Navesink Library

149 Monmouth Ave. Navesink, NJ

Upon inspection the following problems were confirmed at the Navesink Branch Library located 149 Monmouth Ave, Navesink, NJ.

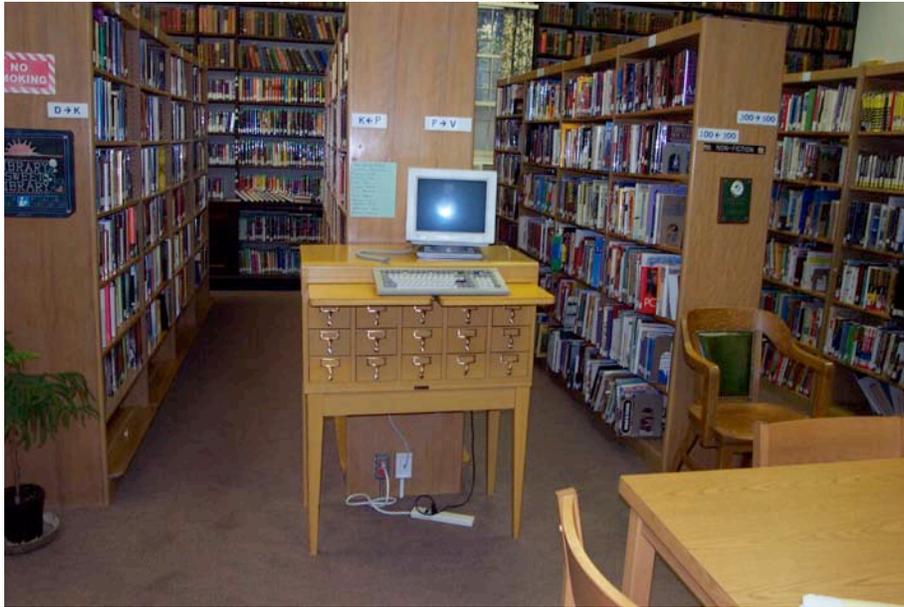
(b.) The bathroom in the theater portion of the building (see picture below), is accessible except for a few areas such as the flush valve on the toilet water tank. These bathrooms and a path to these bathrooms needs to be available to a guest using this library.
